Dominion Nuclear Connecticut, Inc.  
Millstone Power Station  
Rope Ferry Road  
Waterford, CT 06385

Millstone Power Station, Unit No. 2  
Response to Request for Additional Information on RR-89-48 for the  
Nozzle Inspection Ultrasonic Test Coverage Requirements in Order EA-03-009

Response to Request for Additional Information on RR-89-48 for the  
Nozzle Inspection Ultrasonic Test Coverage Requirements in Order EA-03-009

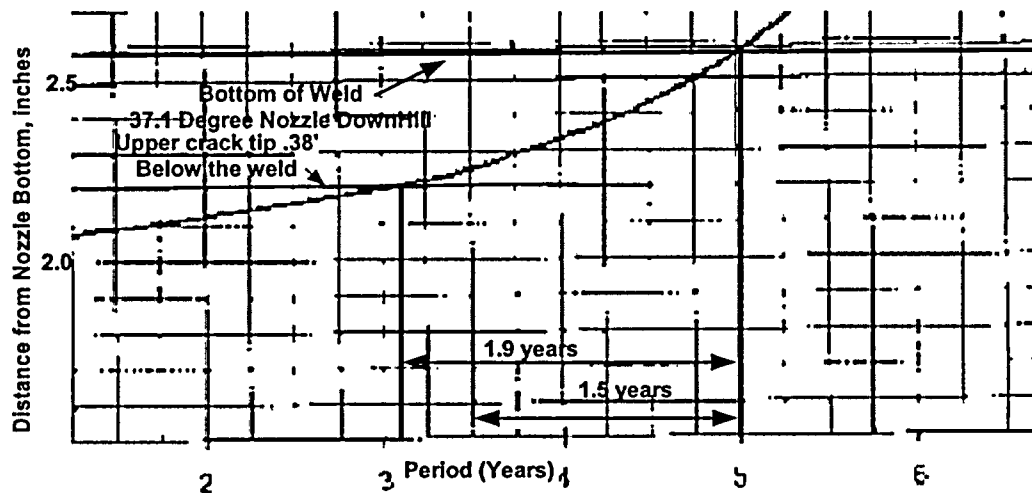
8. *Discuss the basis for the 0.38 inch level below the J-groove weld. From what point on the J-groove weld will the 0.38 inches be measured?*

The basis for the 0.38 inch criteria came from an evaluation of the data collected during the previous inspection in March 2002 and the application of this information to the crack growth prediction curves found in the WCAP. As discussed in the response to question 12 below, the point that UT is calling the bottom of the weld is where weld metal stops. This is conservative since the theoretical tangent of the fillet weld is closer to the head. The data from March 2002, had a number of points

clustered around 0.38 inches below the weld and 0.30 inches below the weld. A check of the 0.30 dimension on the crack growth prediction curves showed that for most of the nozzles the predicted time for a through wall flaw to grow to the weld was less than 1.5 years. At the 0.38 inch dimension, the predicted times were as shown in the Millstone submittal. The Figure below shows the graphical determination of the time until a crack 0.38 inches below the weld reaches the bottom of the weld for the 37.1 degree penetration which turned out to be the most limiting case. This Figure is an enlarged section of Figure 6-15 from WCAP 15813-P.

SECTION VIEW B-B  
Q CLOSURE HEAD LOOKING NORTHEAST  
AT NOZZLES 14, 34 & 59  
SCALE: NONE

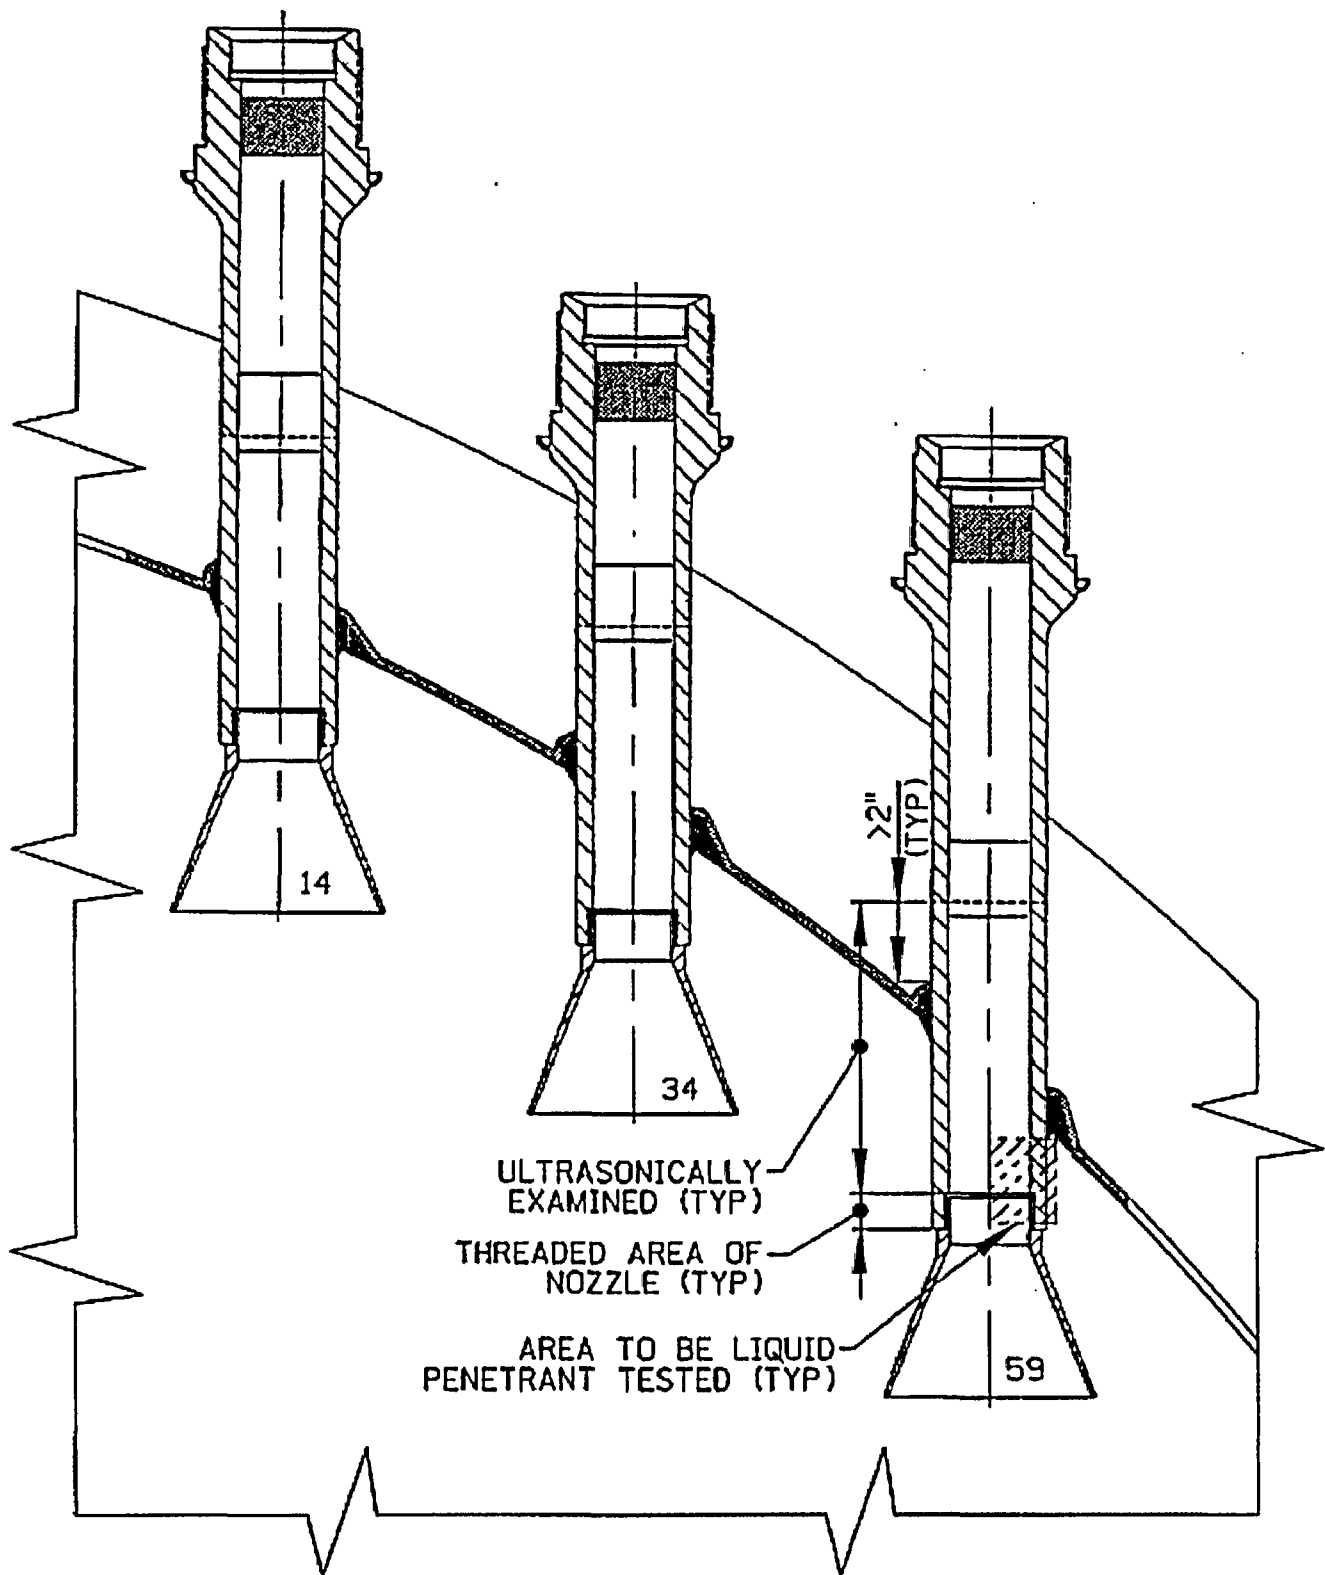
2. *Provide the scope of the PT surface examinations, and the flaw tolerance on each CEDM penetration. What is the proposed area to be examined? Will the examination be 360 degrees around the nozzle? Provide a drawing or drawings showing the area to be examined by PT. Will the surface examination be performed to the bottom of the nozzle?*

UT examination coverage obtained is a full 360° around the nozzle. The proposed area to be PT examined will be 180° of the nozzle Outside Diameter (OD) centered on the downhill side, (see attached Figure, Section View B-B), from the toe of the weld at the lowest point on the weld, extending down to cover approximately 3/4 inches of the nozzle base material. This examination will overlap the area that was examined ultrasonically and extend below to obtain the desired coverage. An attempt will be made to avoid examining the end of the nozzle, (approximately 1/4 inches from the bottom), because the bleed-out of the penetrant from the mating surface between the nozzle end and funnel could mask the area of interest.
